#### City of Maple Ridge

# SPECIAL COUNCIL MEETING AGENDA August 7, 2018 6:00 p.m. Council Chamber

SUBJECT: Development Variance Permit

23025, 23054, 23060 and 23075 Lougheed Highway

DETAIL 1 - BUILDINGS 3&4

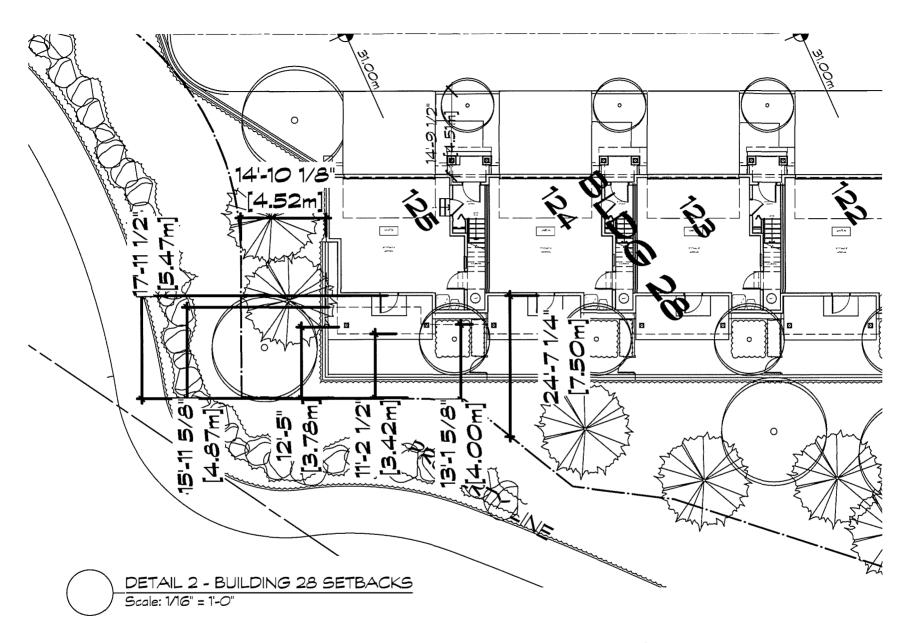
- 1. Maple Ridge Zoning Bylaw No. 3510-1985, 602 RM-1 Townhouse Residential District Section 6. Siting a) to vary the exterior side setback (to the cul-de-sac) for Building 3 and 4 from 7.5 metres to:
  - 6.19 metres to the closer front faces and 6.95 m to the further front faces;
  - 5.58 metres for the building overhangs:
  - 4.33 metres to the front balcony posts; and
  - 4.15 metres to the front balcony overhang.

Exterior Side lot line along Palerina Place for Buildings 3 and 4: From  $7.5~\mathrm{m}$  to:

- $\boxtimes$  6.19 m to closer front faces and 6.95 m to further away front faces
- $\boxtimes$  5.58 m for the building overhangs

DETAIL 3 - BUILDING 25 SETBACKS

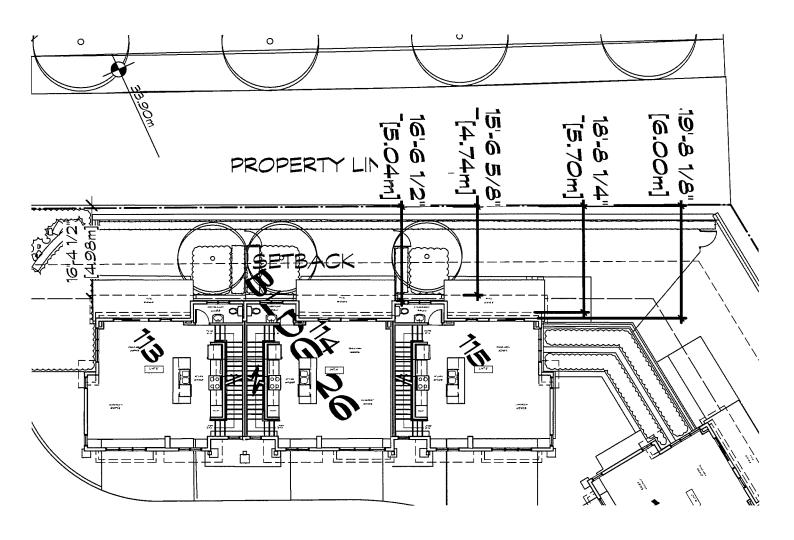
- 2. Maple Ridge Zoning Bylaw No. 3510-1985, 602 RM-1 Townhouse Residential District Section 6. Siting a) to vary the front setback (to Lougheed Highway) for Buildings 25 from 7.5 metres to:
  - 4.72 metres to the closer front faces and 4.42 for its associated overhang; and
  - 5.67 metres to the further front faces and 5.37 for its associated overhang.

Front lot line setback variances along Lougheed Highway for Buildings 25 and 26: From 7.5 m to:

- $\boxtimes$  4.42 m for the building overhangs
